ADDENDUM 3

DATE: November 18, 2016
PROJECT: MSB First Floor Infill LRC 3 & 4
RFP NO: 744-R1705
OWNER: The University of Texas Health Science Center at Houston
TO: Prospective Proposers

This Addendum forms part of and modifies Proposal Documents dated, October 19, 2016, with amendments and additions noted below.

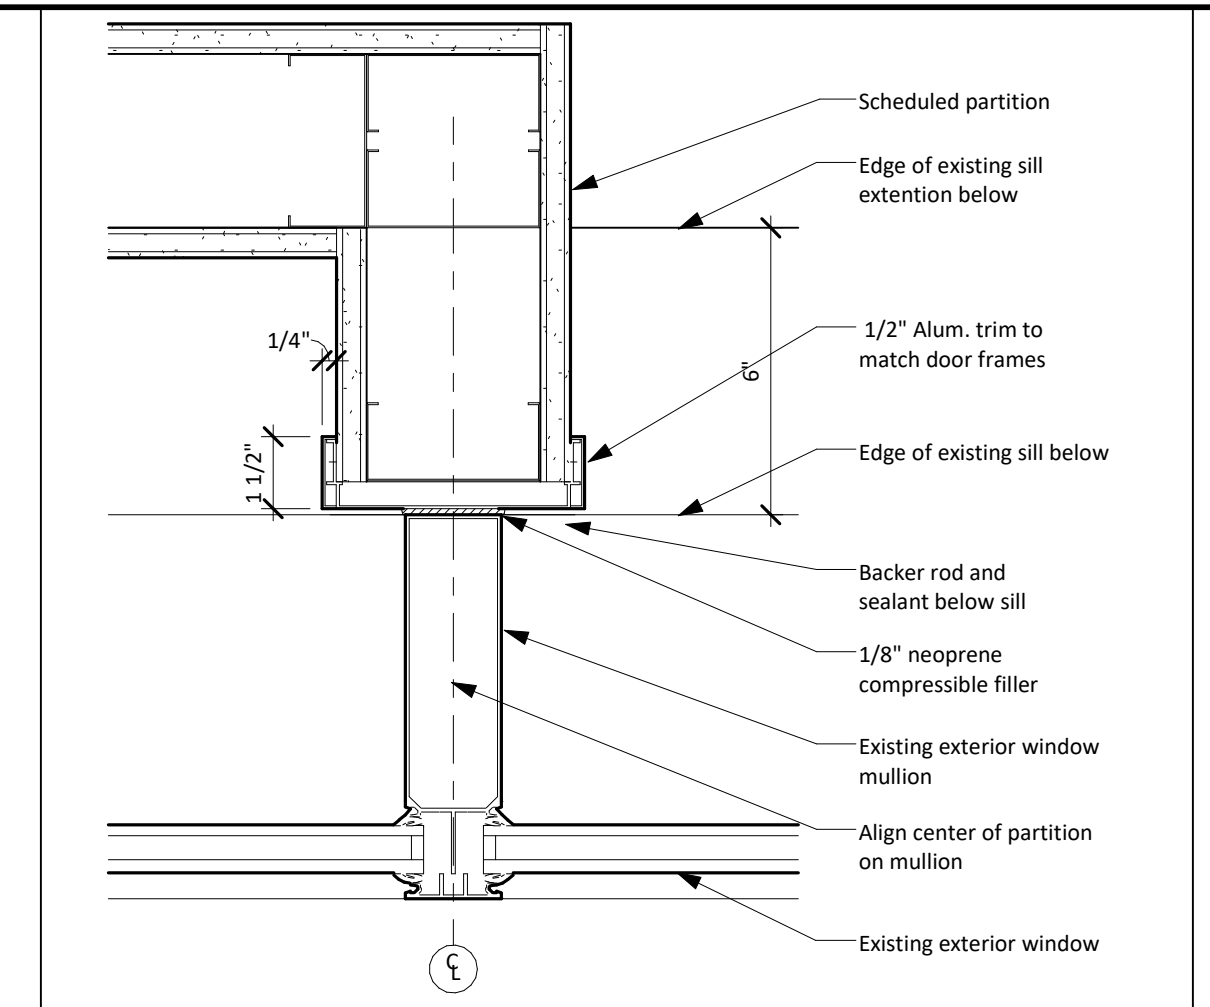
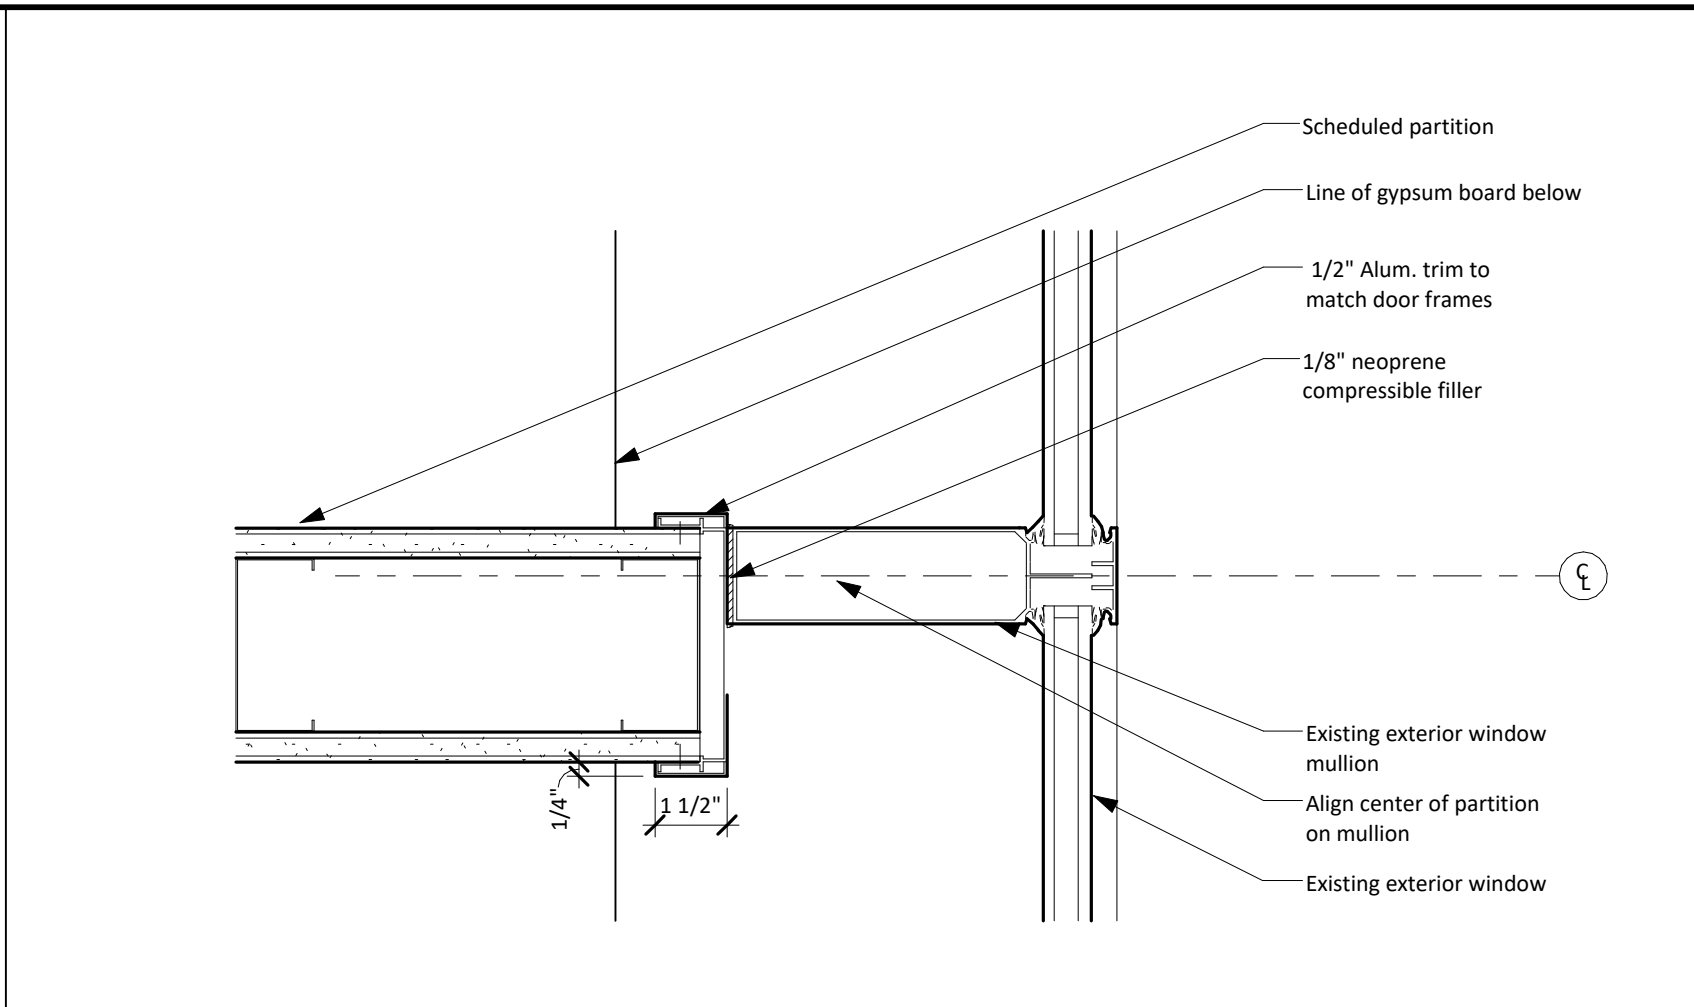
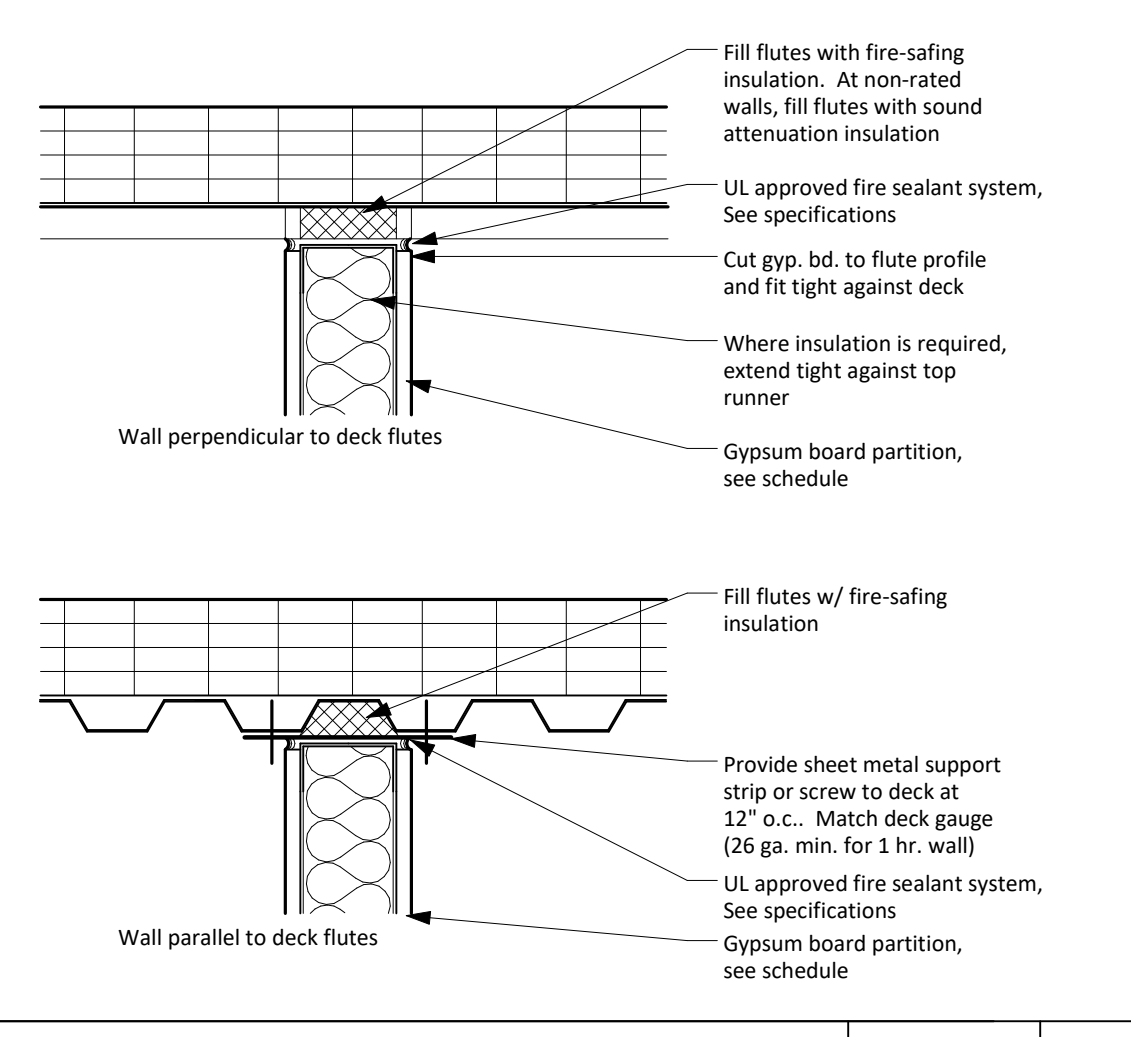
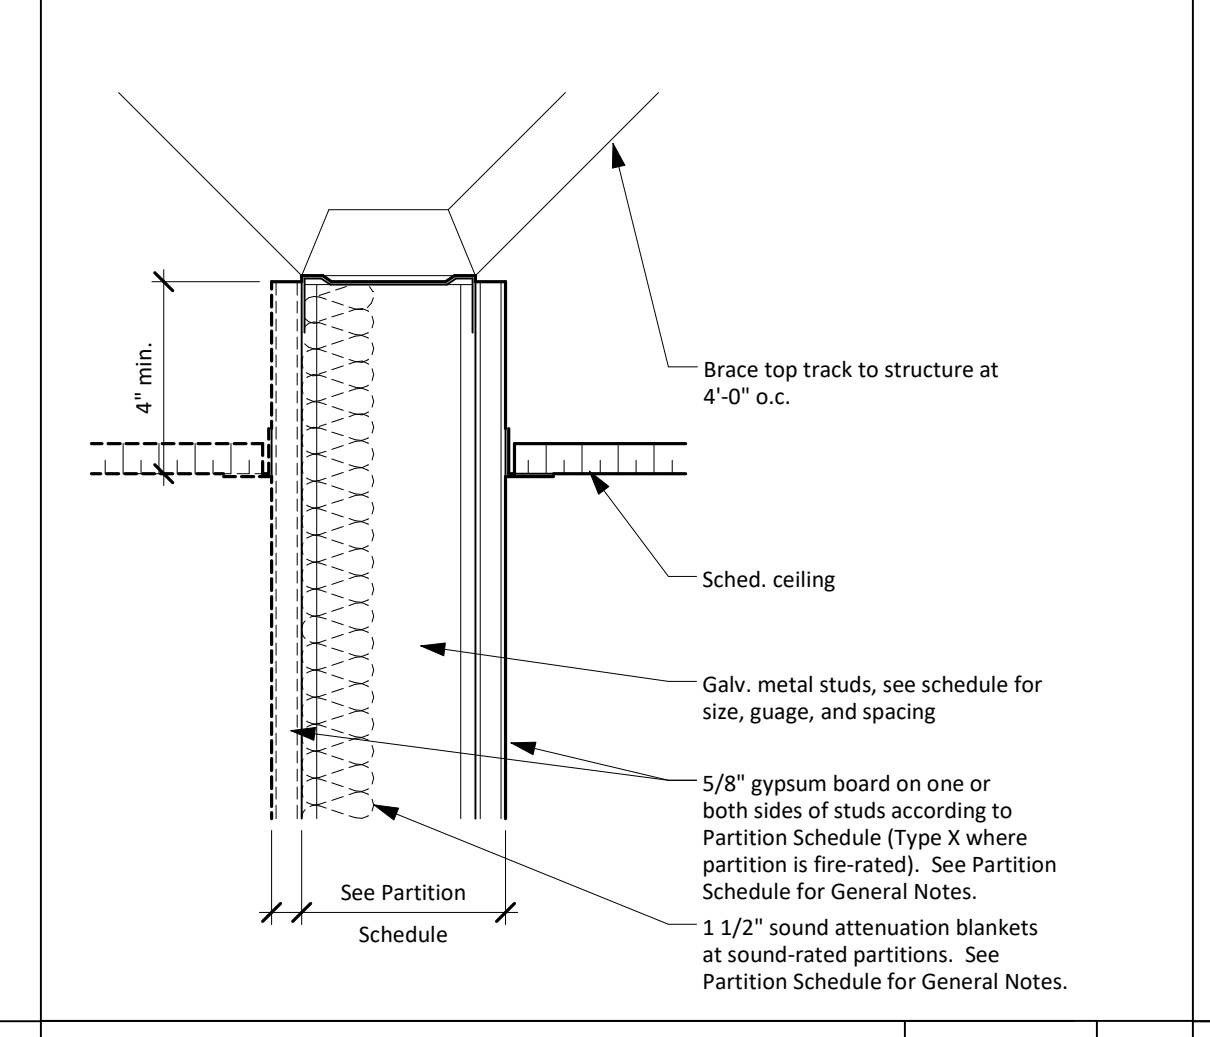
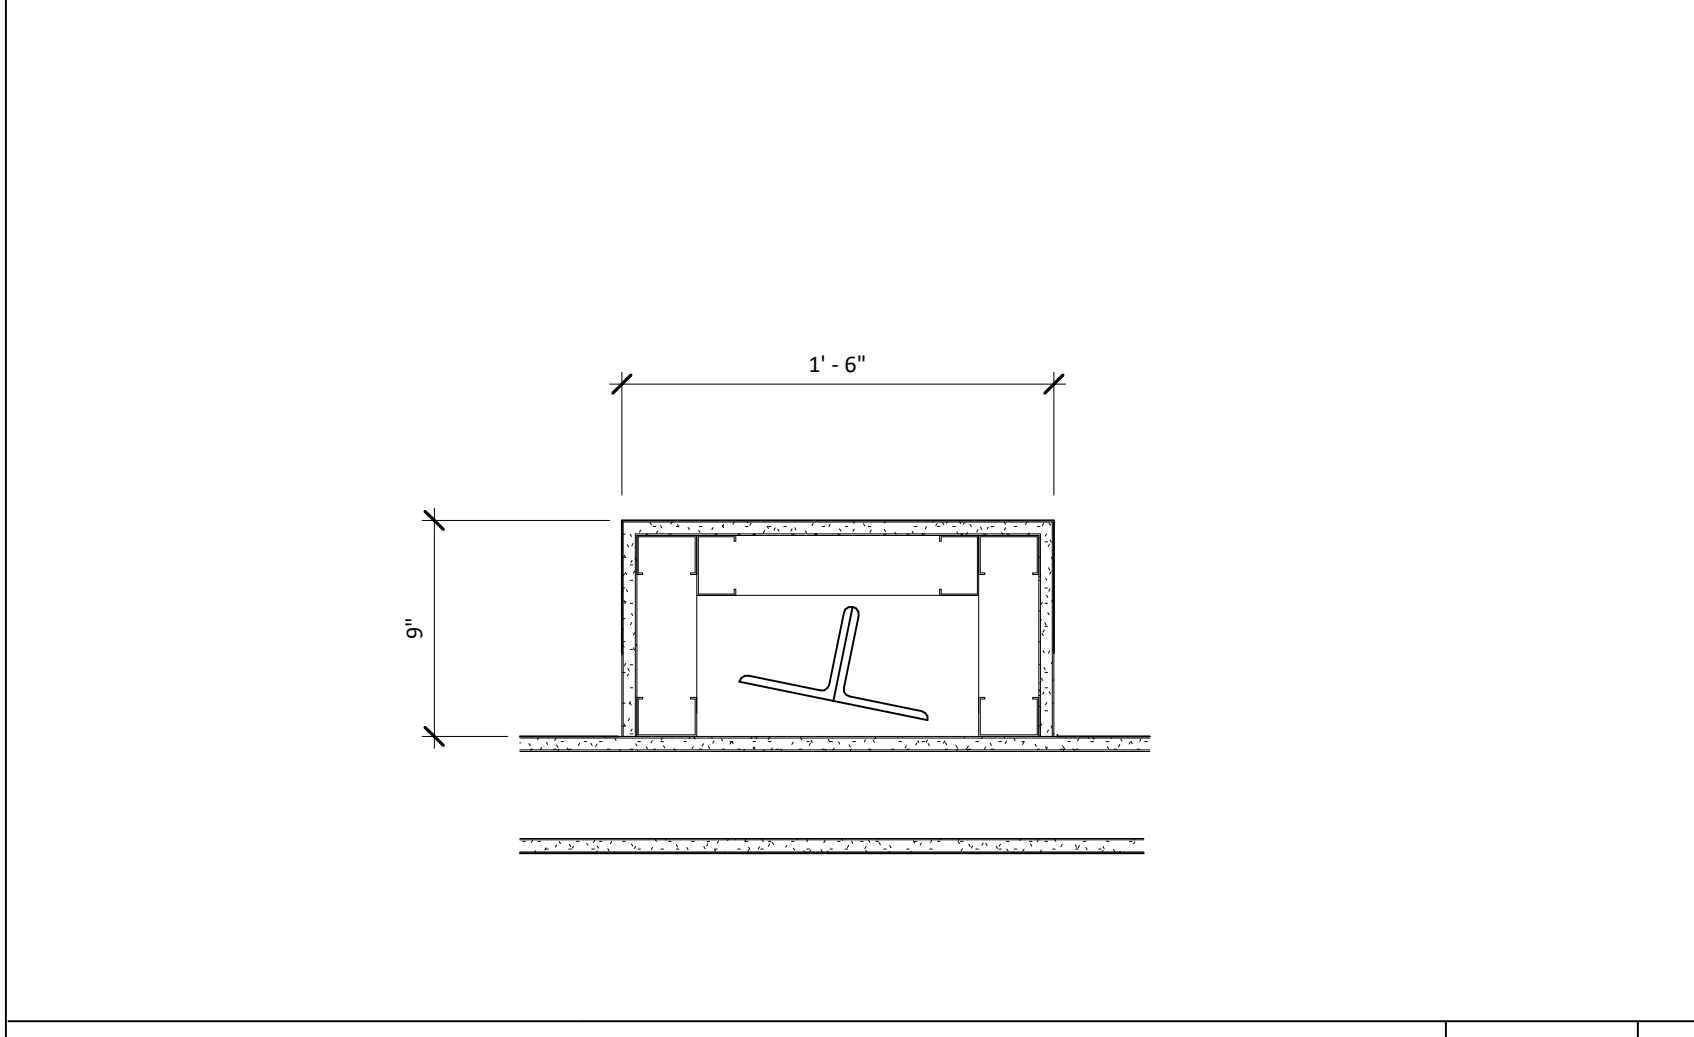
15. Provide a revised sheet showing exit signs to be replaced in Alternate #3.
Addressed within this Addendum.
16. Please provide a spec section for the "black-out" window film called out for on detail 16 on A-520.
Existing spandrel glass, note removed

17. Please provide details, 21/A-520, 22/A-520 and 23/A520. They are called out in the partition type schedule but are not shown on sheet A-520.
Wall type removed, will not be rated

23. On drawing A-520 - Partition Types and Interior Construction Details (Detail 18), detail shows ceiling to tie in to top of window with slot diffuser. The top of existing window is below the 9' ceiling height that is called for on the plans. Please advise. **Ceiling heights are now 8' ceilings, furr down will be required. New detail provided within this addendum.**

28. On drawing A-540 – Please confirm the notated door color is correct.
VT Industries Red Oak Veneer/ Alpine AL07
29. On drawing 16/A520 – Please provide specifications for the aluminum sill extension shown.
Included within this Addendum.

P&W Commission Number: 3339.00
Sheet Number: DM1.01A

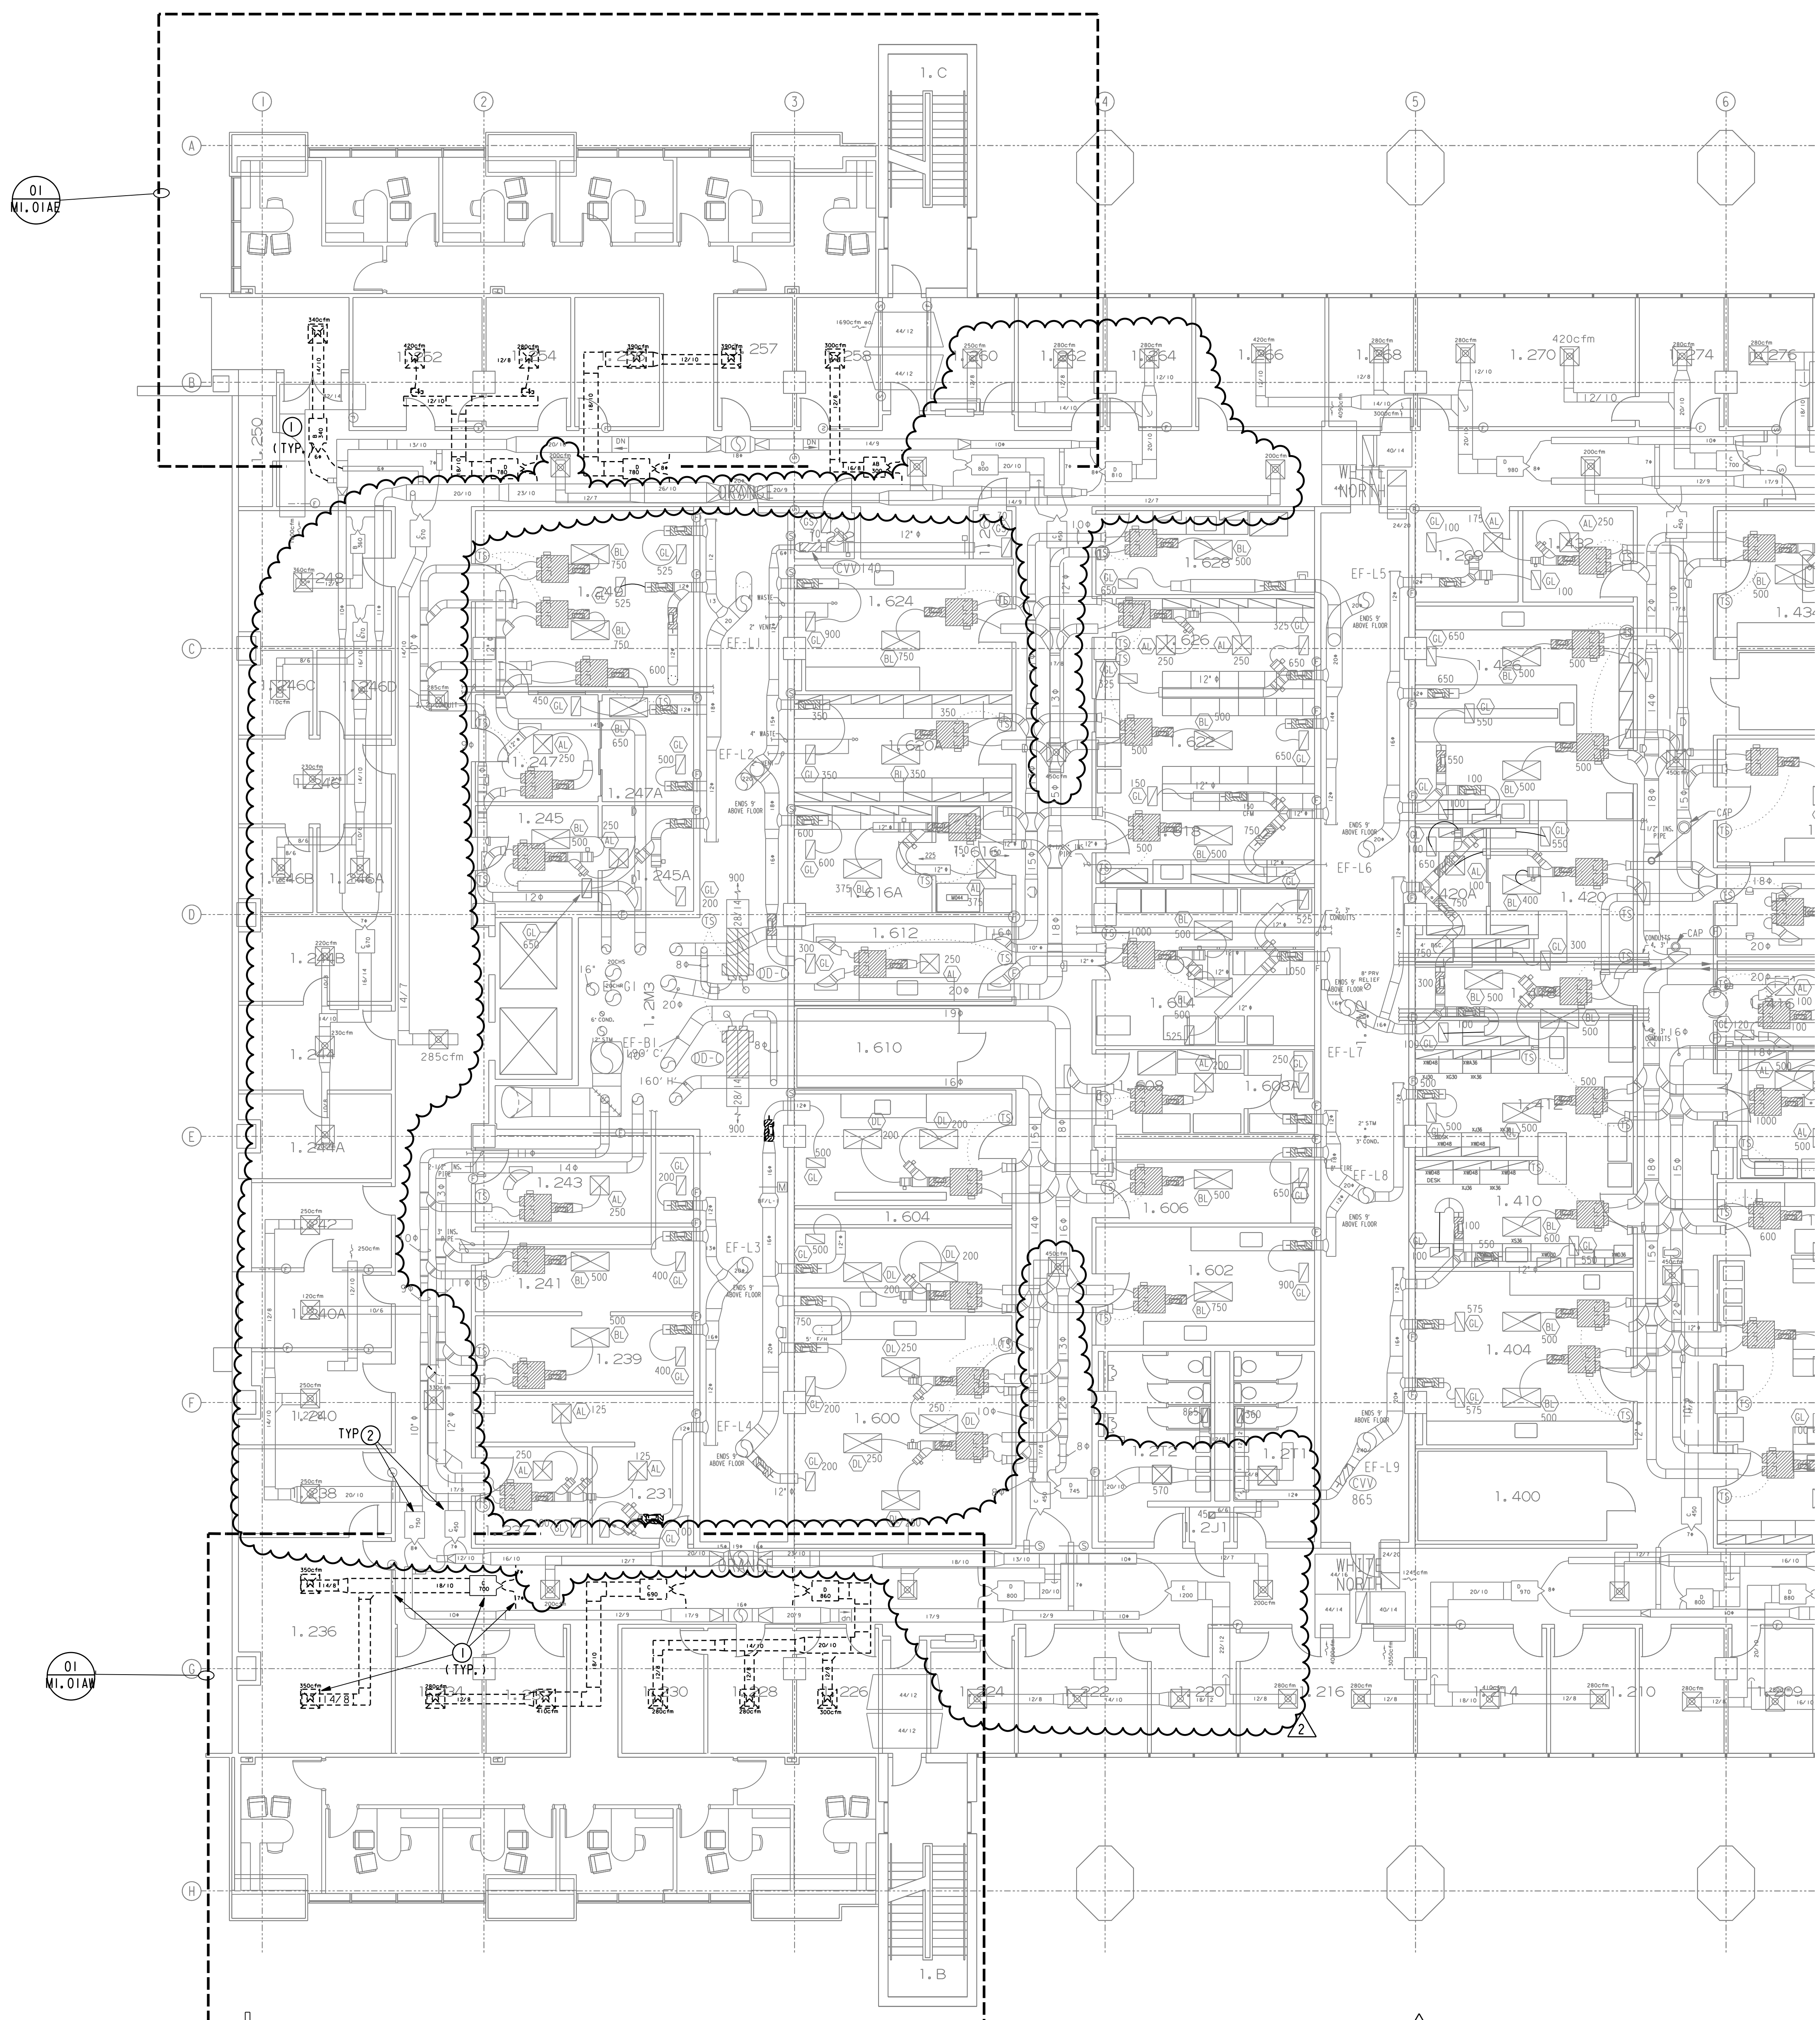
9. General note D on page DM1.01A states to remove all existing tubing back to the main for any pneumatic terminal units, are there any pneumatic terminal units within out scope of work? If so, where please show on drawing or detail?
No General Note D on DM1.01A. Note 1 on DM1.01A clearly notes to remove dashed existing HVAC.
